工程指示 / 要求簡箋(E.I.)

工程指示編號：EI / 5635 / 24

工程名稱：將軍澳日出康城 11

工程項目：幕牆 特色層室外收口鋁板 放行 AQ51-55, AQ56-57 修改 地盤用

工程號	J858	類別		物料號	-		
地盤	康城11期	制圖	W. E. X	2022-11-11	圖號	AQ-51	
修改	-	採用工廠	地盤	✓	圖紙名稱	鋁板加工圖	
日期	-	材料顏色	PVF2 (香檳金)	材料	3.0mm 鋁板	數量	-
						單件重量	- (KG)

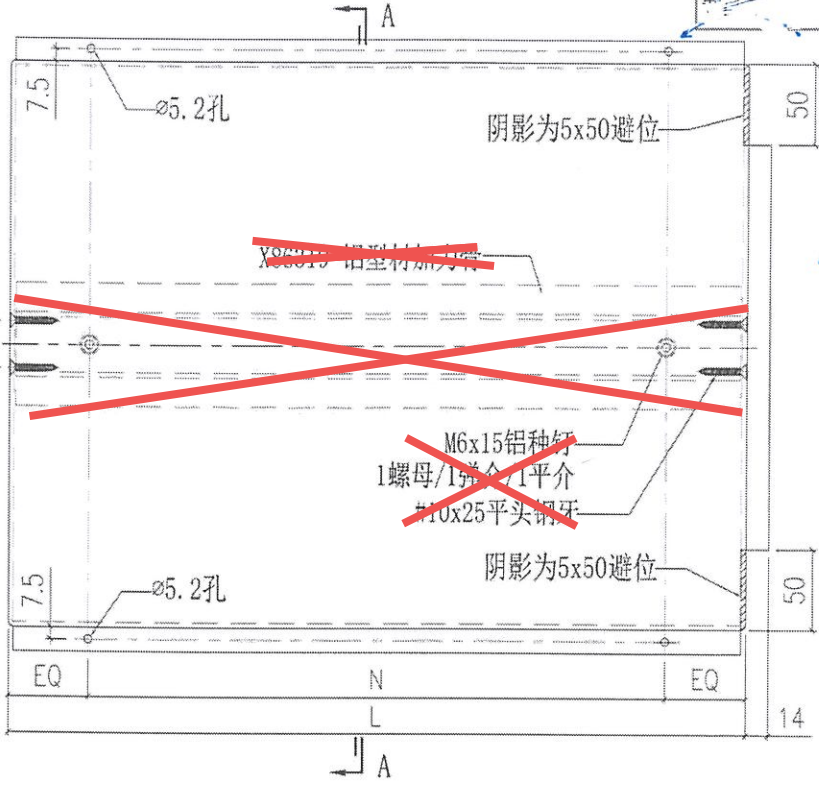
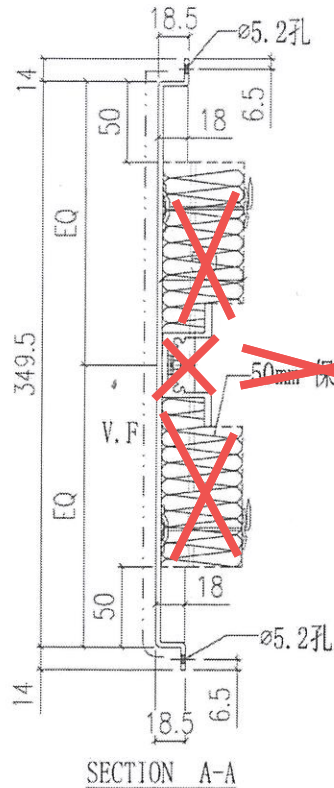
放行

不用加力骨，
不用棉

美特鋁質有限公司 MIDI Aluminium Fabricator Ltd.			工程號 J858 地盘 康城11期	類別 制圖 W. E. X	物料號 - 2022-11-11	圖號 AQ-52
修改 - - - 日期 - - -	採用工廠 <input checked="" type="checkbox"/> 地盤 <input checked="" type="checkbox"/> 材料颜色 PVF2 (香槟金)	图纸名称 铝板加工图 材料 3.0mm 铝板	復核 - - 批准 - -	數量 - 單件重量 - (KG)

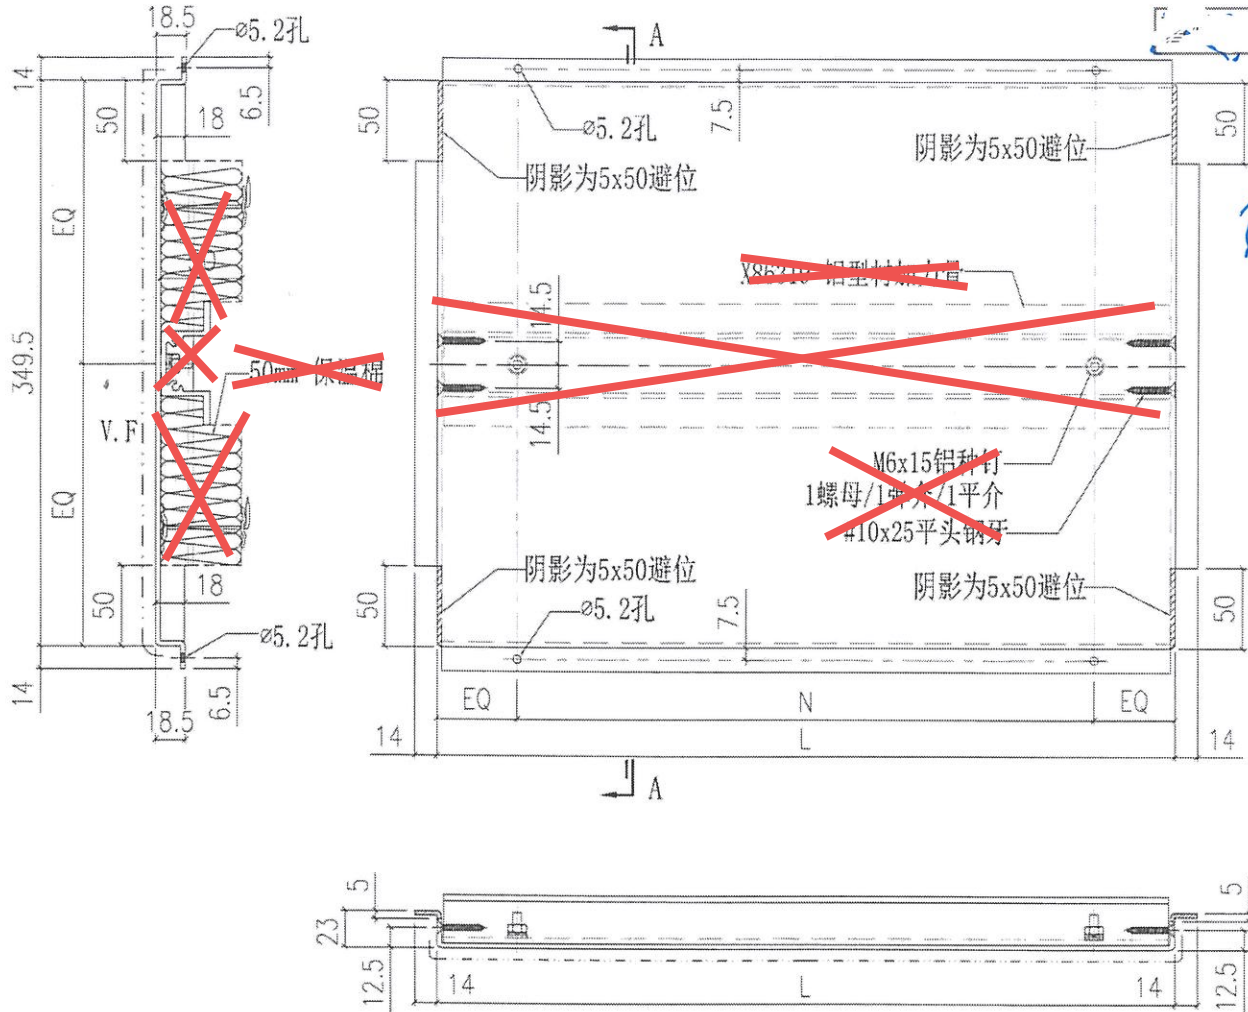
放行

不用加力骨，
不用棉

工程號	J858	類別		物料號	-
地盘	康城11期	制圖	W. E. X	2022-11-11	圖號 AQ-53
修改	-	採用工廠	✓	地盤	✓
日期	-	材料颜色	PVF2 (香槟金)	图纸名称	铝板加工图
				復核	-
				批准	-
				數量	-
				單件重量	- (KG)

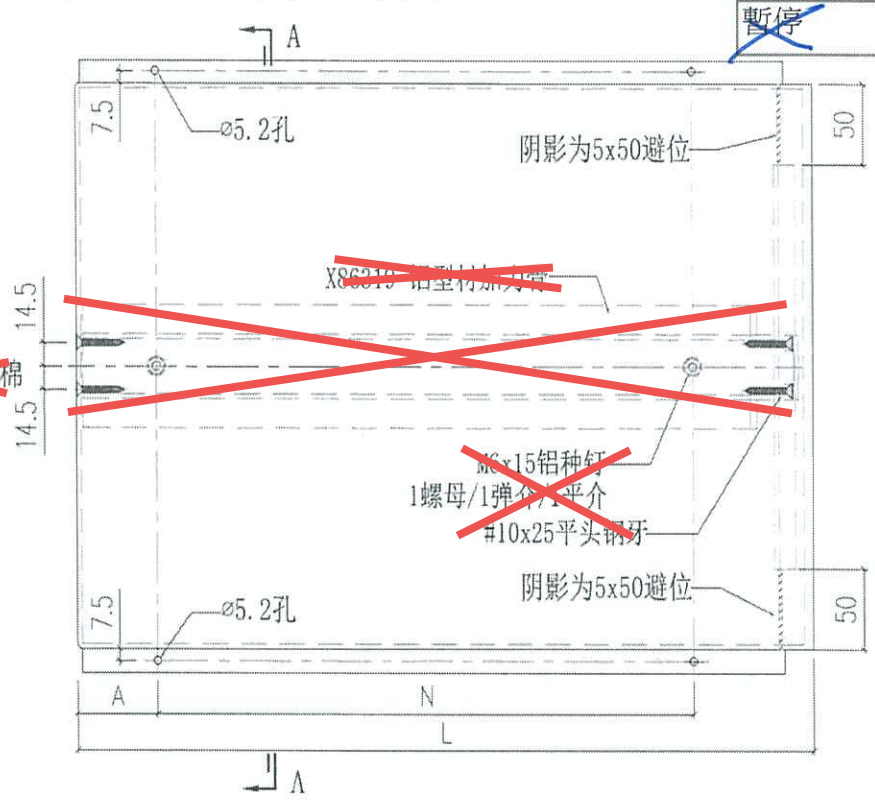
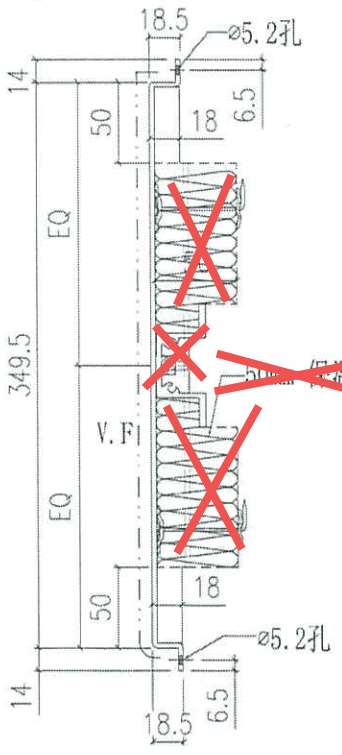
放行

不用加力骨，
不用棉

工程號	J858	類別		物料號	-						
地盤	康城11期	制圖	W. E. X	2022-11-11	圖號	AQ-54					
修改	-	採用工廠	✓	地盤	✓	圖紙名稱	铝板加工图	復核	-	數量	-
日期	-	材料顏色	PVF2 (香槟金)	材料	3.0mm 铝板	批准	-	單件重量	-	(KG)

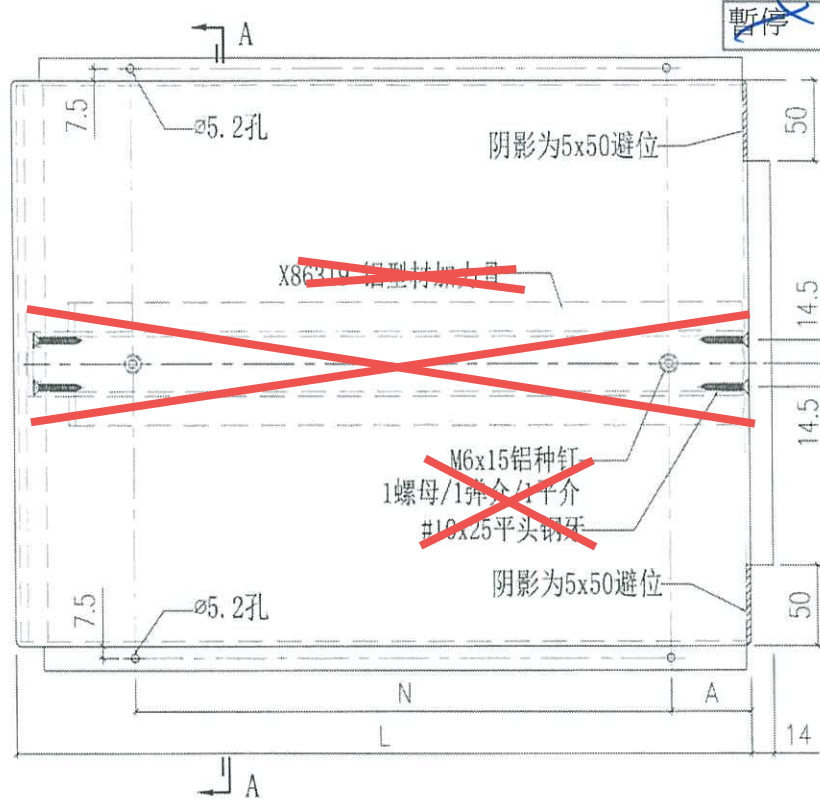
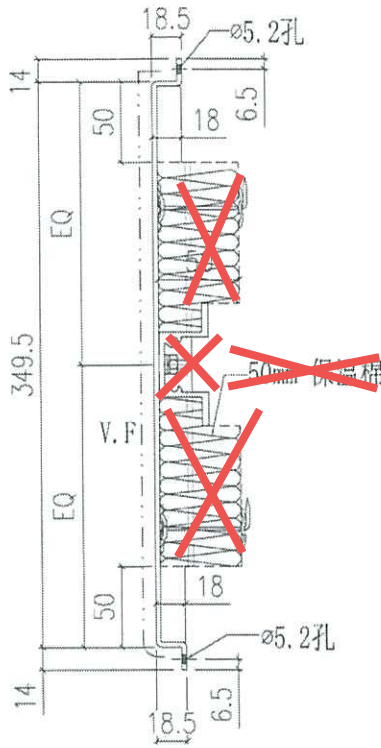
不用加力骨，
不用棉

放行

美特铝质有限公司 MIDI Aluminium Fabricator Ltd			工程號 J858 地盘 康城11期	類別 制圖 W. E. X	物料號 - 2022-11-11	圖號 AQ-55
修改 - - - 日期 - - -	採用工廠  地盤 	图纸名称 铝板加工图	復核 - - 批准 - -	數量 - 單件重量 - (KG)		
材料颜色 PVF2 (香槟金)		材料 3.0mm 铝板

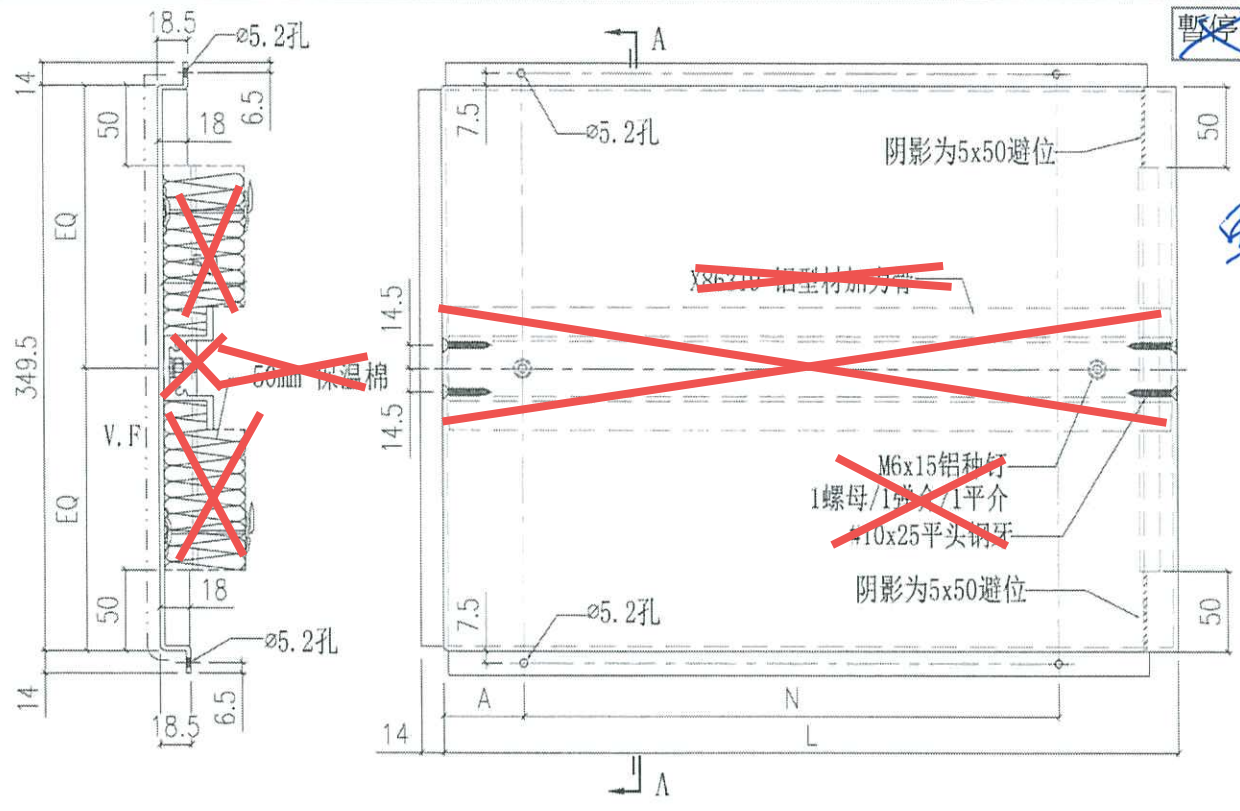
放行

不用加力骨，
不用棉

美特铝质有限公司 MIDI Aluminium Fabricator Ltd.				工程號	J858	類別		物料號	-				
				地盘	康城11期	制圖	W. E. X	2022-11-11	圖號	AQ-56			
修改	-	-	-	採用工廠	<input checked="" type="checkbox"/>	地盤	<input checked="" type="checkbox"/>	图纸名称	铝板加工图	復核	-	數量	-
日期	-	-	-	材料颜色	PW2 (香槟金)	材料	3.0mm 铝板	批准	-	-	單件重量	-	(KG)

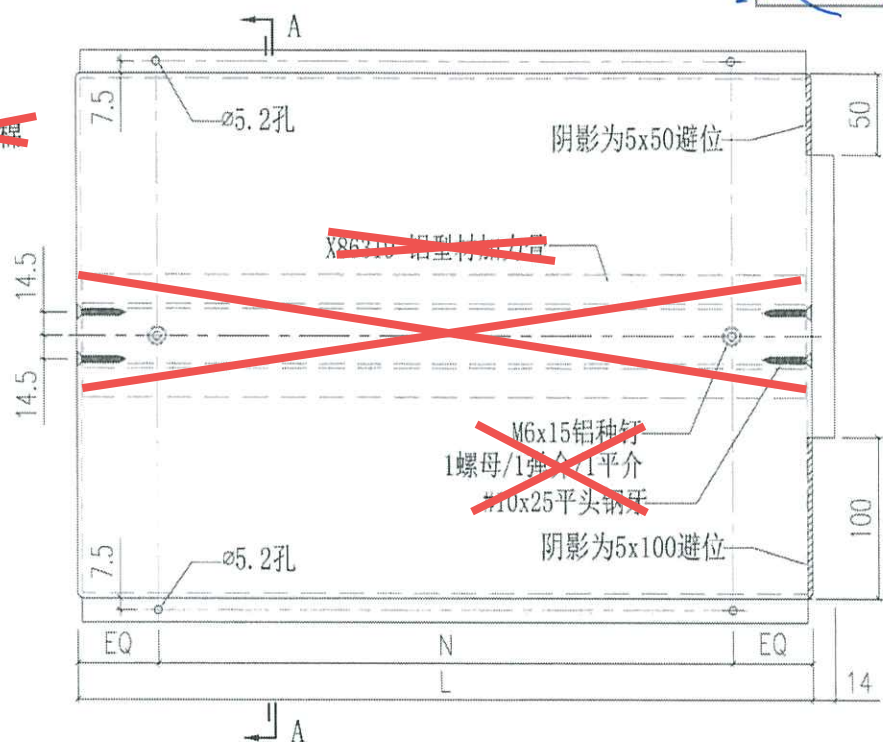
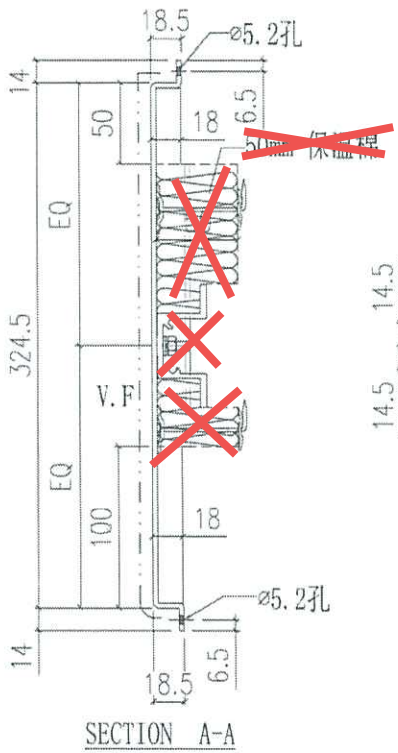
放行

不用加力骨，
不用棉

美特鋁質有限公司 MIDI Aluminium Fabricator Ltd.		工程號 J858 地盘 康城11期 图纸名称 铝板加工图 材料 3.0mm 铝板	類別 制圖 W. E. X 復核 - 批准 -	物料號 - 2022-11-11 - -	圖號 AQ-57 數量 - 單件重量 - (KG)
修改	-	採用工廠 <input checked="" type="checkbox"/> 地盘 <input checked="" type="checkbox"/>	日期	-	材料颜色 PV2 (香槟金)

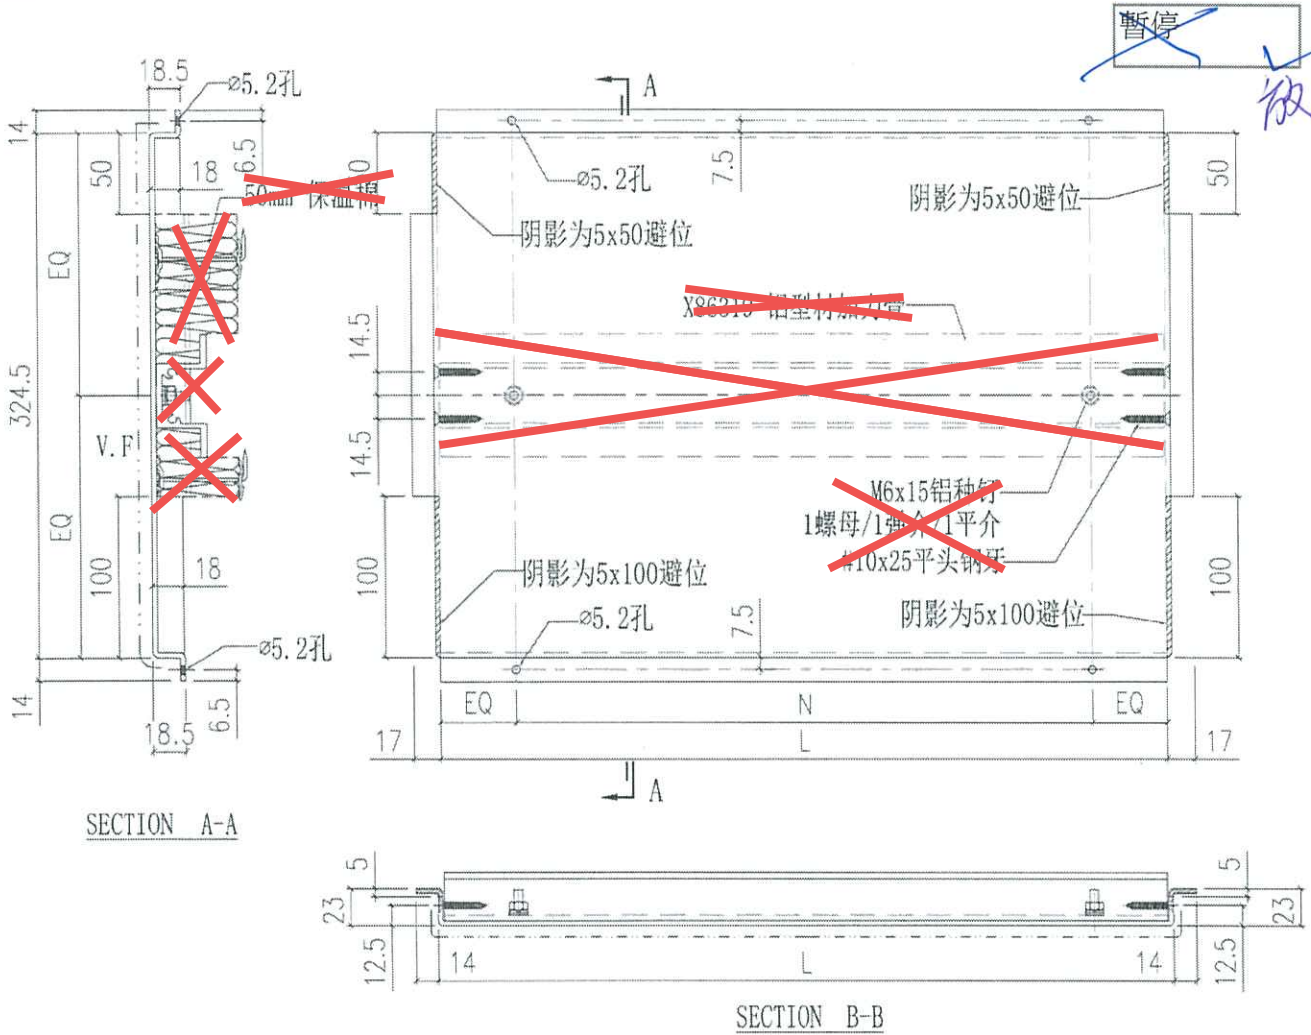
不用加力骨，
不用棉
